HISTORIC AND DESIGN REVIEW COMMISSION

HDRC CASE NO: 2019-128
ADDRESS: 212 LOSOYA ST
210 LOSOYA ST
201 LOSOYA ST
UZROW
LEGAL DESCRIPTION: NCB 145 BLK LOT E 74.42 OF 1 *COMMON ELEMENT* 124 E
CROCKET CONDOMINIUMS
ZONING: D,HS,UZROW,HS
CITY COUNCIL DIST.: 1
DISTRICT: Alamo Plaza Historic District
LANDMARK: Chamber of Commerce Building
APPLICANT: Mariano Martino/City of San Antonio
OWNER: City of San Antonio
TYPE OF WORK: Installation of sidewalk art panels
APPLICATION RECEIVED: March 05, 2019
60-DAY REVIEW: May 04, 2019
CASE MANAGER: Stephanie Phillips
REQUEST:

The applicant is requesting a Certificate of Appropriateness for approval to remove existing sidewalk vault light panels and install 23 sidewalk art panels in the right-of-way adjacent to 210, 212, and 201 Losoya St.

District One Pedestrian Mobility – Sidewalk Vault Lights (201 & 210 Losoya Street)

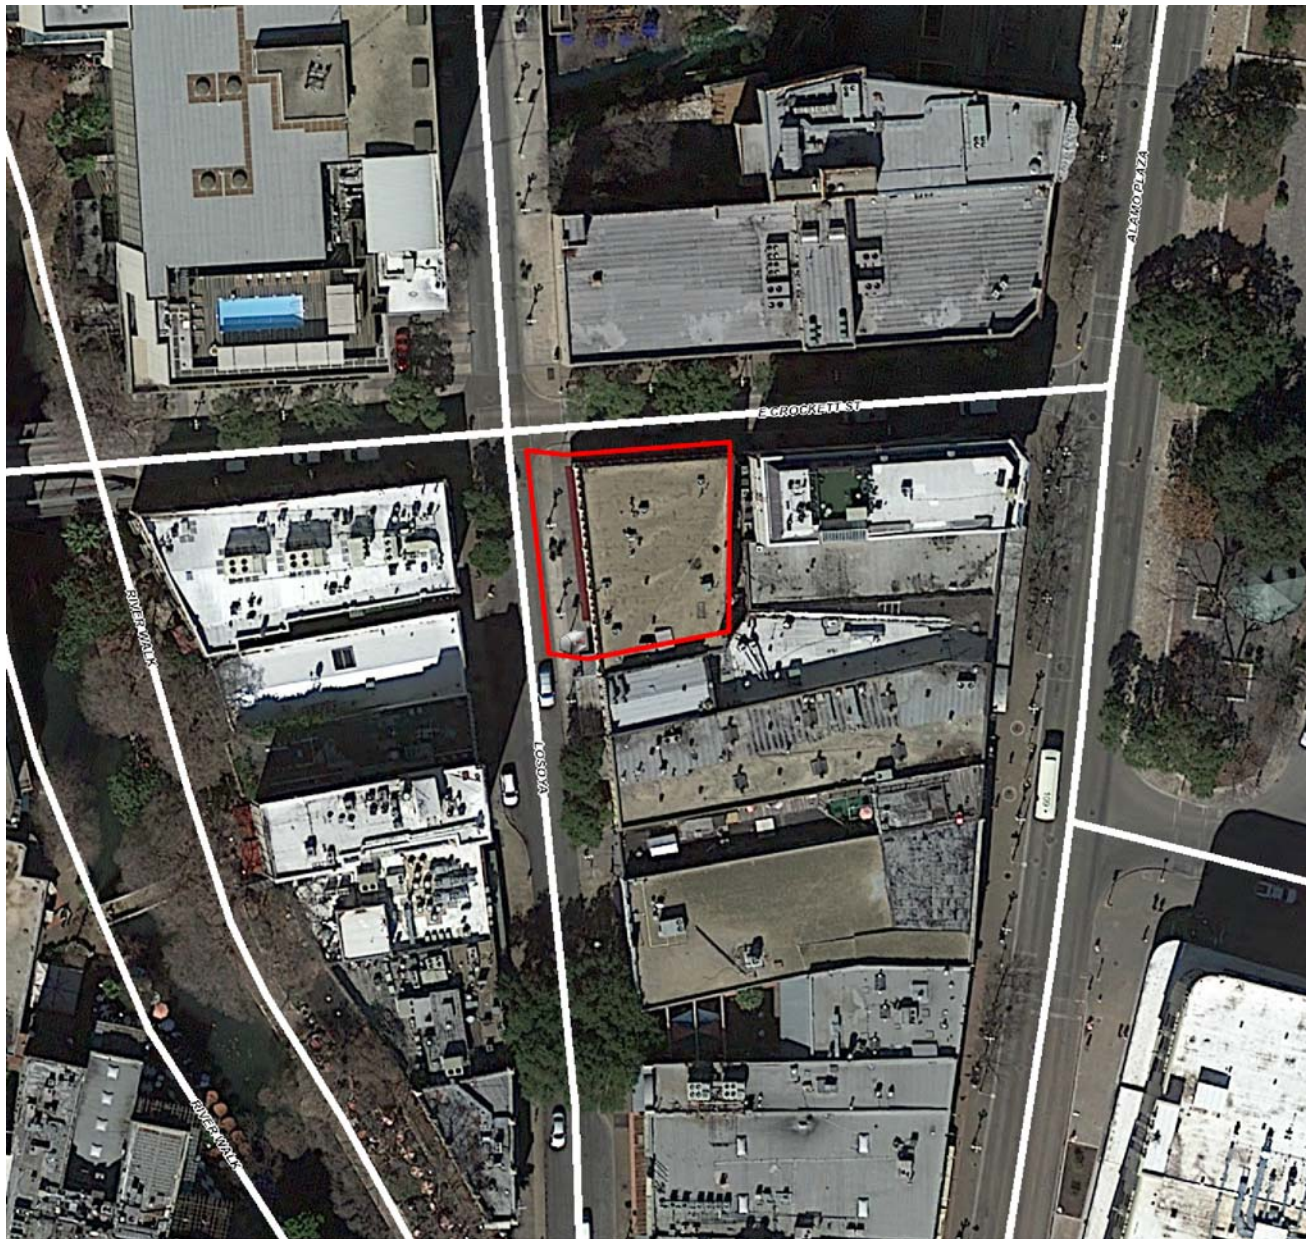
- b. **SIDEWALK PANELS** – The applicant has proposed to replace 23 existing sidewalk vault light panels located in front of the buildings with new decorative art panels. Per the applicant’s analysis, the existing light panels have been deteriorated beyond repair to the point where they no longer maintain their integrity. The proposed new panels will be installed in the location of the existing to retain a sense of continuity and denote the location of the original panels. The new panels will be manufactured from structural concrete panels, exposed glass aggregate, terrazzo, and aluminum divider strips. The panels will feature a continuous linear pattern with blue, teal, cream,

and brown integral coloring. According to the Historic Design Guidelines, glass block pavers or similar street features should be repaired using in-kind materials whenever possible. Similar materials that are compatible with the original should be used when in-kind replacement is not possible. Overall, staff finds the proposal to be a sensitive and acceptable approach that will maintain the existing configuration of the sidewalk, but finds that Panel 1 and Panel 2 along Crockett St, and Panel 1 and Panel 10 along Losoya St, are not damaged beyond repair and should be restored. Staff finds that the applicant should restore Panel 1 and Panel 2 on Crockett St in place and relocate Panel 1 and Panel 10 on Losoya St to the Crockett St locations to create a contiguous cluster of original sidewalk lite vaults, resulting in the retention of a portion of the original sidewalk configuration and materiality, to be more consistent with the Historic Design Guidelines.

- i. That the applicant restores Panel 1 and Panel 2 on Crockett St in place and relocates Panel 1 and Panel 10 on Losoya St to the Crockett St locations to create a contiguous cluster of original sidewalk lite vaults as noted in finding b. The applicant is required to provide updated drawings and related project plans to staff for review and approval prior to the issuance of a Certificate of Appropriateness.
- ii. That the applicant provides the Office of Historic Preservation with an inventory of all known sidewalk vault lites in San Antonio as well as a proposed schedule of those to be repaired or replaced as noted in finding c. This inventory must be provided prior to the issuance of a Certificate of Appropriateness.
